Addendum No. 1

Contract No.: DA00332

Replacement of Existing Pipes / Culverts in Bertie and Camden Counties

ADDITIONAL CULVERT UNDERCUT:**Description**

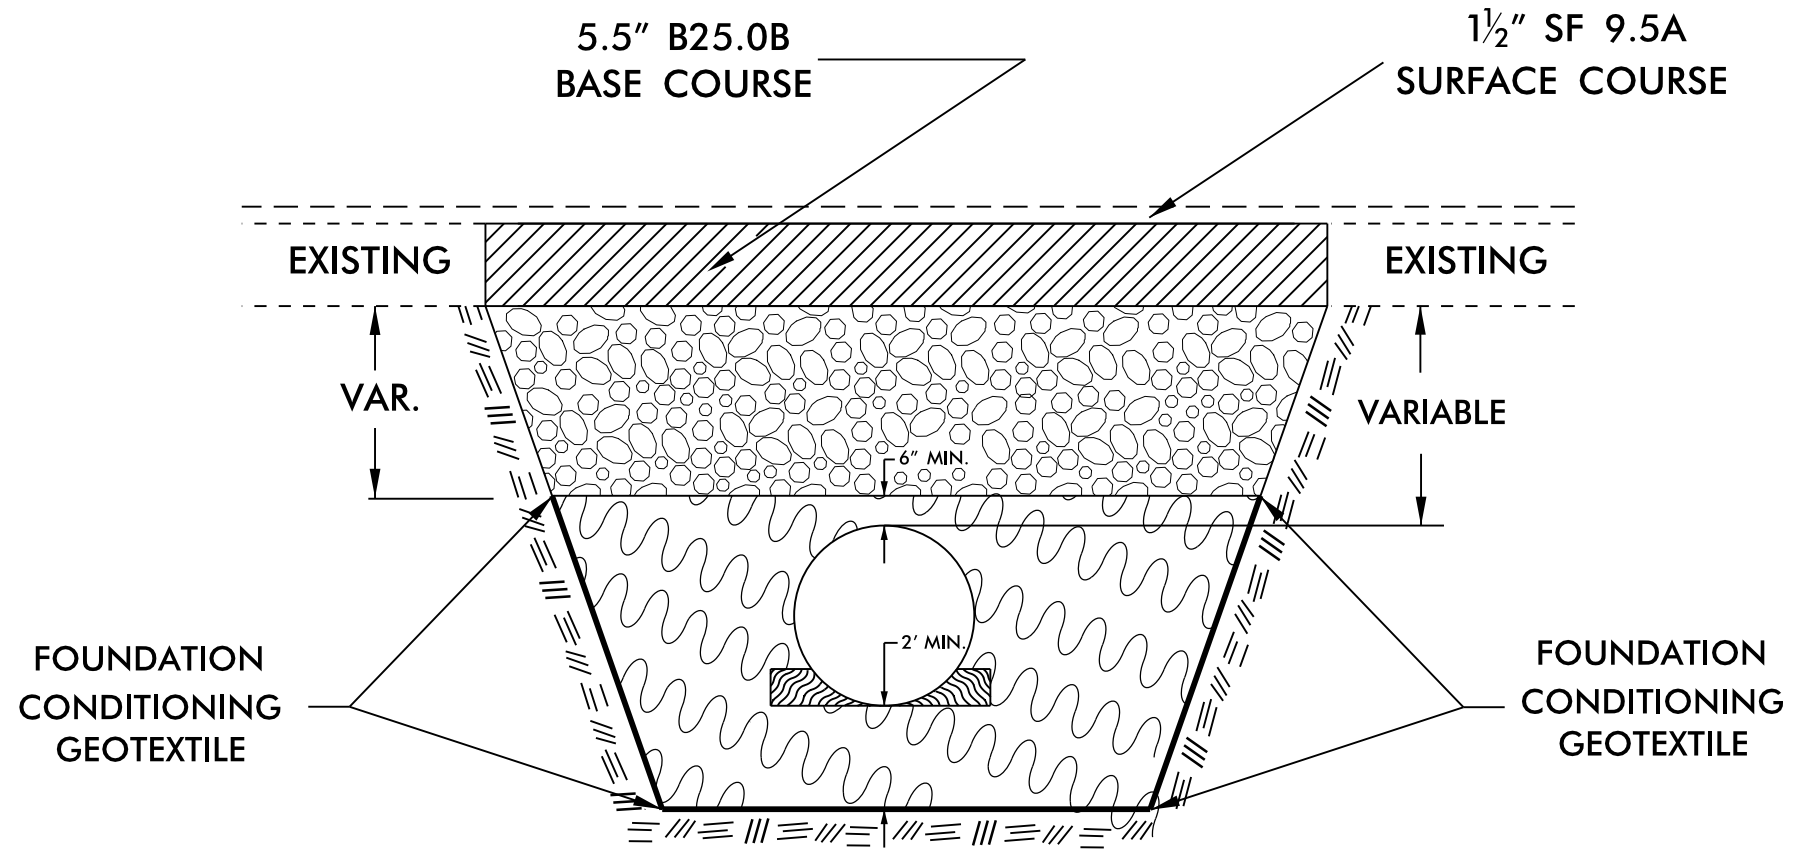
Page No.68 “Additional Culvert Undercut” has been revised to clarify the depth requirements. Please void existing Page No. 68 and replace with revised Page No. 68.

Any undercut beyond the specified 2' below pipe bed, that is out of the Contractor's control and as directed by the Engineer, will be paid for at the contract price as *Generic Culvert Item (Additional Culvert Undercut)* by the cubic yard which will be full compensation for all items required for additional undercut.

INSTALLATION DETAIL

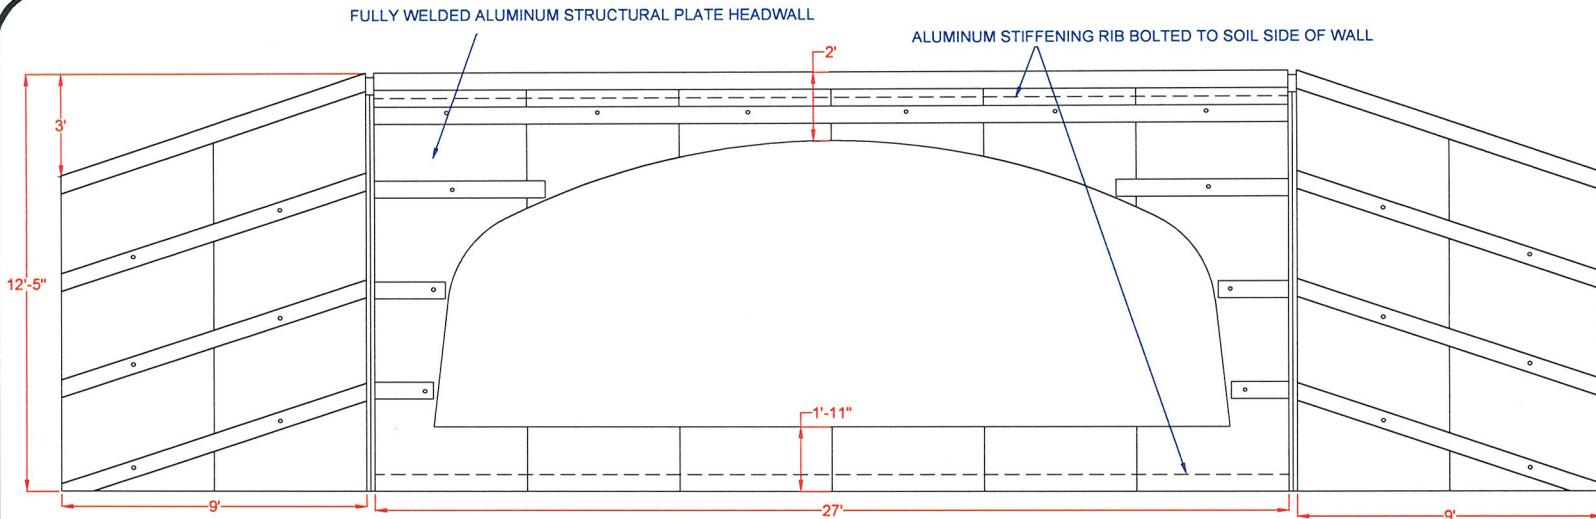
Plan Sheet “Installation Detail” the detail has been revised to clarify the foundation conditioning material and to illustrate the geotextile fabric requirements. Please void the existing Plan Sheet “Installation Detail” and replace with the revised Plan Sheet “Installation Detail”.

SELECT MATERIAL CLASS VI FOR FOUNDATION CONDITIONING MATERIAL
ENGINEERING FABRIC WILL BE INSTALLED BELOW THIS MATERIAL AS DIRECTED BY THE ENGINEER
